M6 JUNCTION 29 SOUTH

Signalisation of Approach Arm
Stage 1 Road Safety Audit

OUR REF. NO. 70084465-RS1

Figure 4-2 -Illustration of proposed secondary signal location

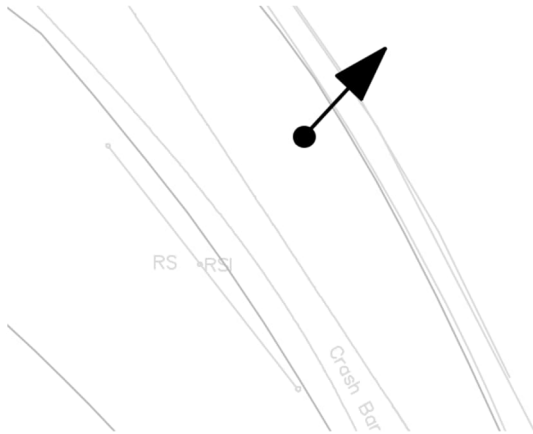
Summary: Proposed signal head / pole to be located in front of VRS and Chevron signs.

The proposed location of the secondary signal for the southbound connector road approach is located in front of the roundabout Chevron signs and in front of the existing Vehicle Restraint System (VRS). This may result in increased severity of injury should any vehicle fail to stop at the traffic signals and strikes the pole.

It is recommended that the secondary traffic signal is located where it will not be in front of the Chevron sign, and behind the VRS. If it is necessary to relocate the VRS it is noted that, as a continuation of the parapet, the VRS may need to be upgraded to meet current standards.

Figure 4-3 - Illustration of visibility angle from nearside lane to nearside primary signal.

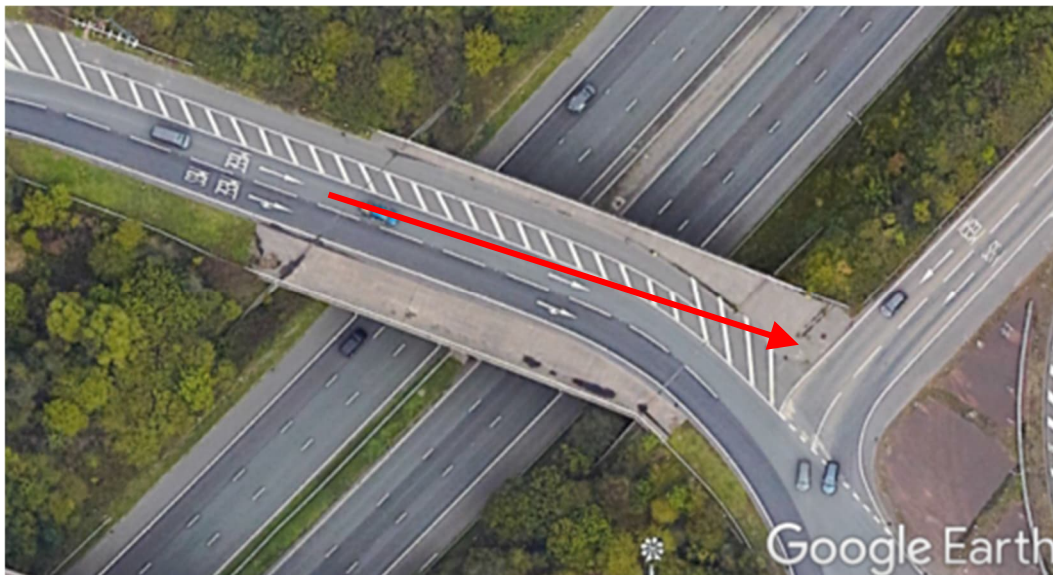
Summary: Proposed build out places traffic signal at a vulnerable location where vehicles losing control may strike the traffic signal.

The design proposes a build out across the width of the hatched area to the near side of the circulatory carriageway. Vehicles losing control within the roundabout and veering towards the near side, would hit the traffic signal or any VRS in front of the traffic signal head-on. The designer has confirmed the intention of the build out is to place the traffic signal closer to the line of sight of drivers in lane 1. However, the curvature of the circulatory carriage way would allow a direct line of sight from lane 1 to a signal placed on the existing kerbed area at the side of the hatching.

It is recommended that the build out is omitted from the design or extended along the length of the hatching so that any vehicles losing control would hit the VRS at a shallow angle.

84465-WSP-XX-DR-020 – Rev P02 Scheme details @1:500

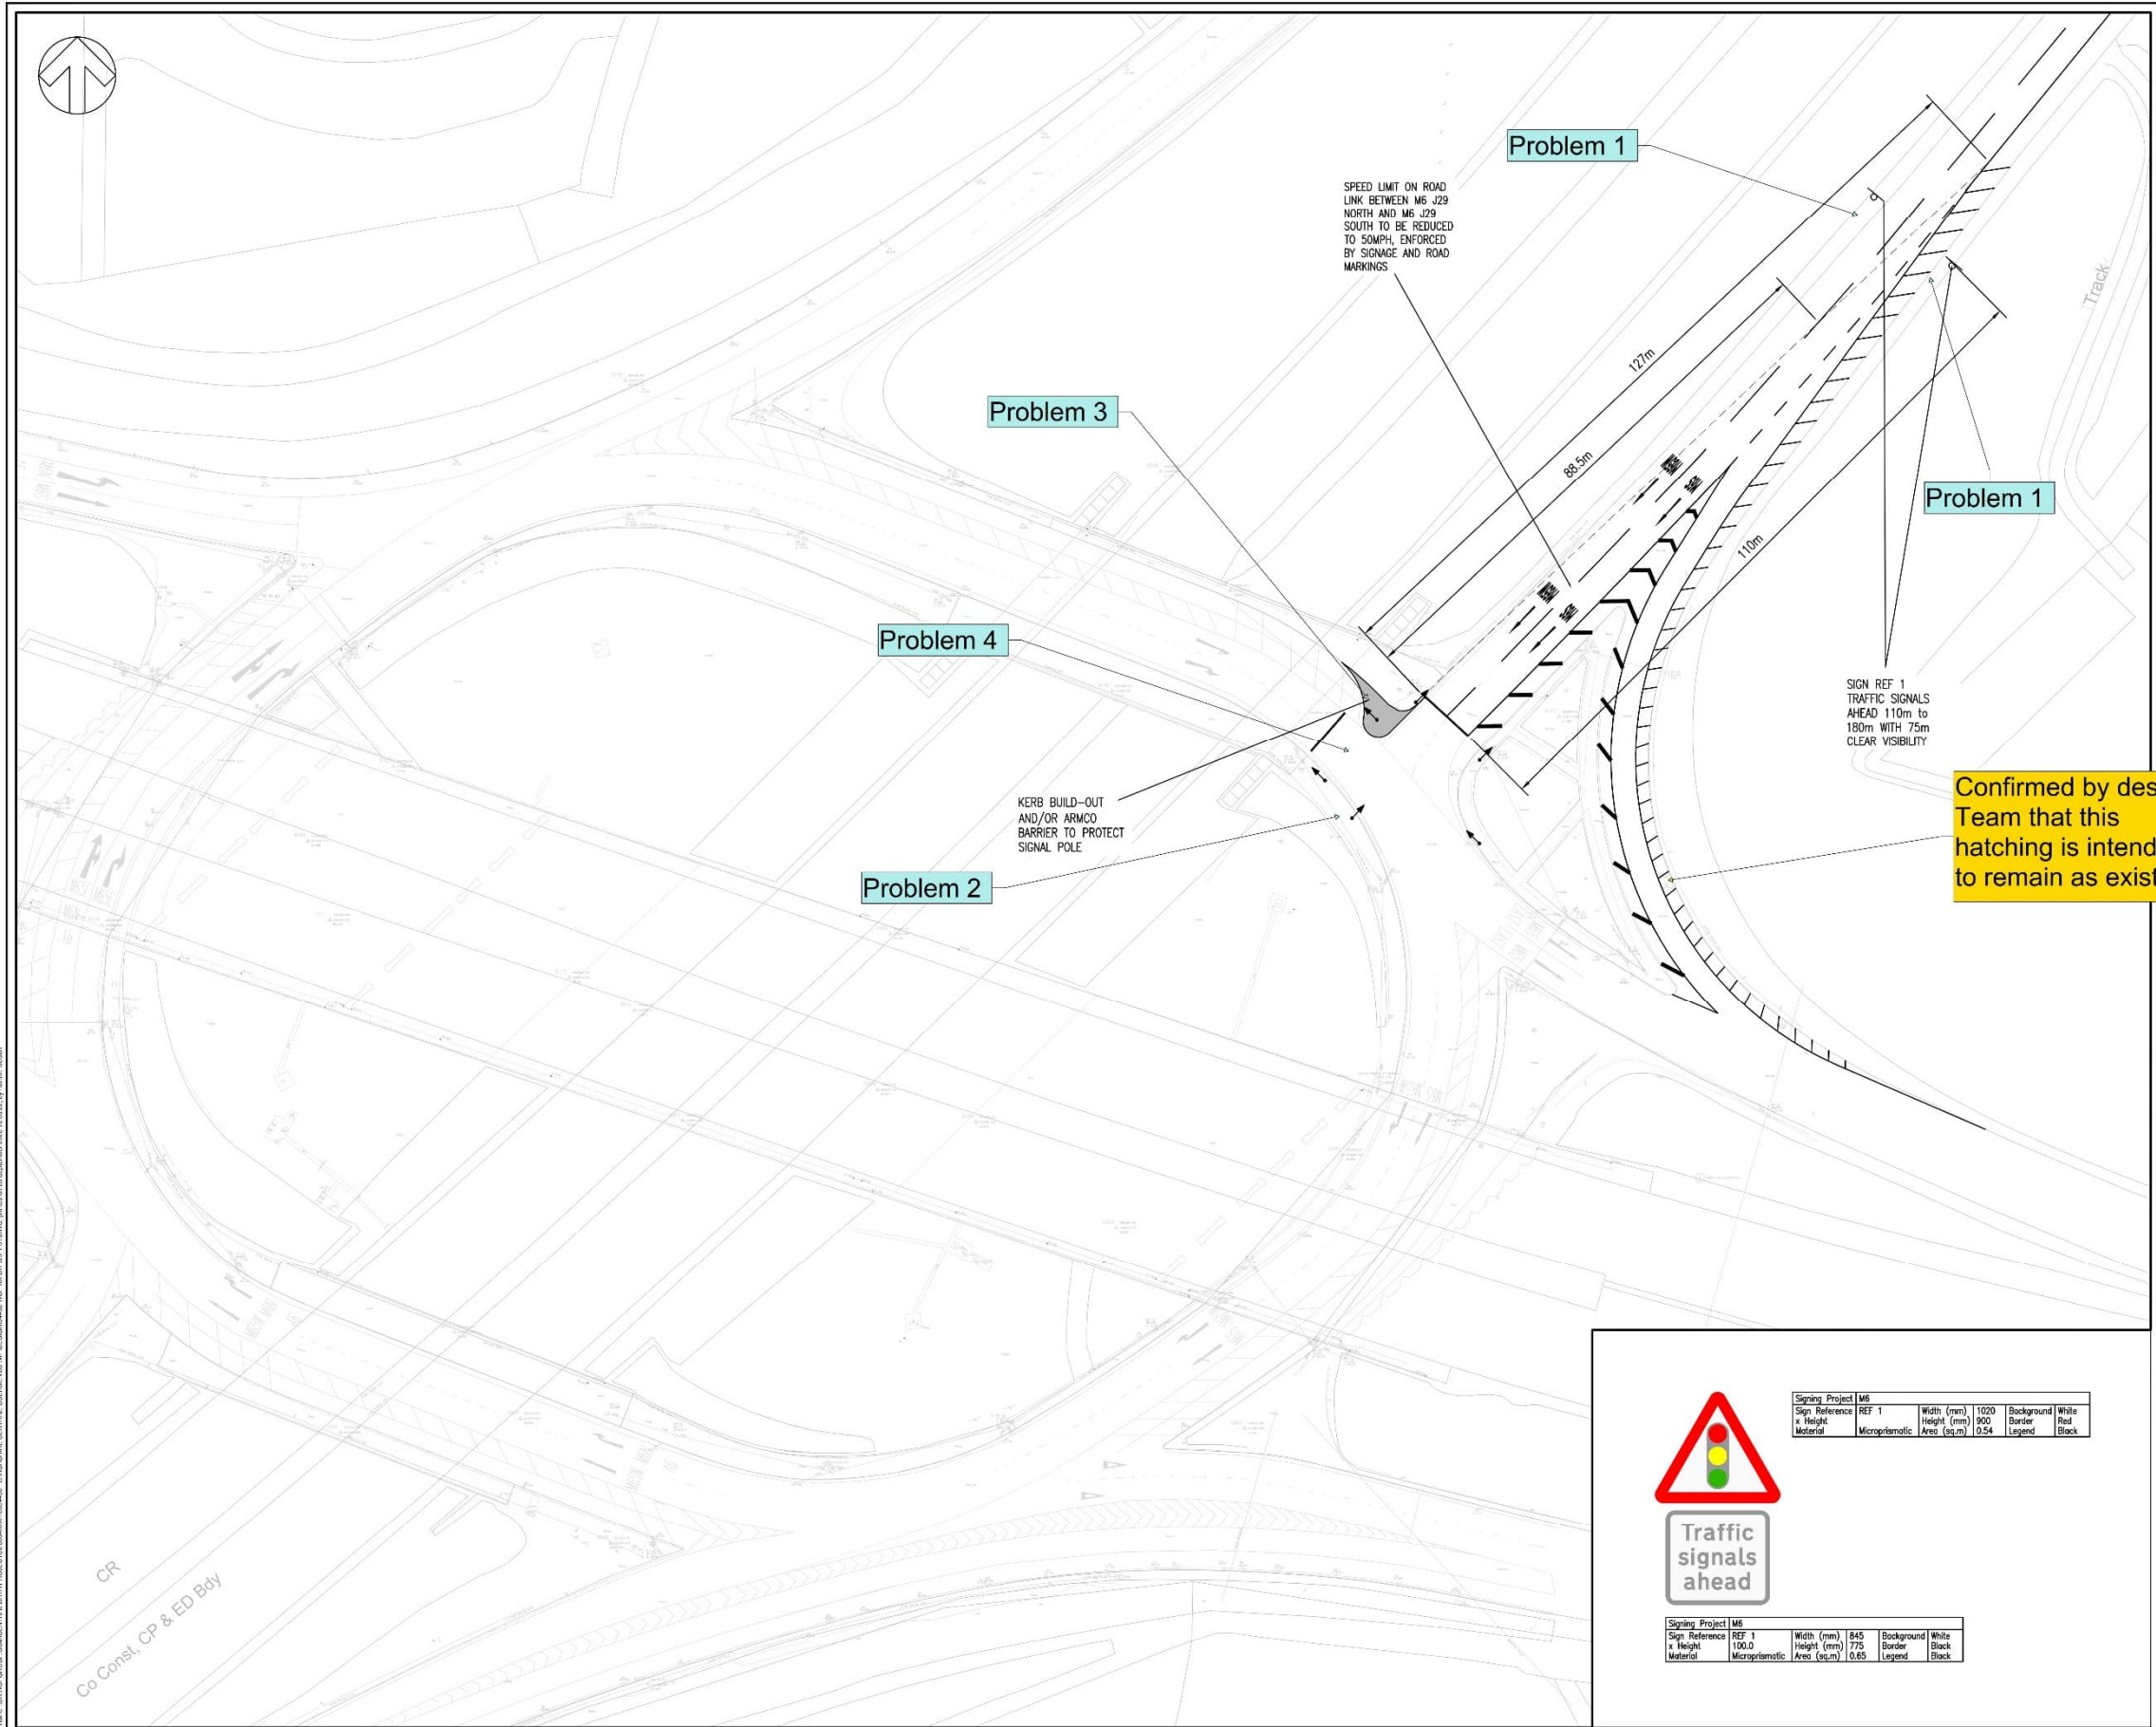
Confirmed by design Team that this hatching is intended to remain as existing
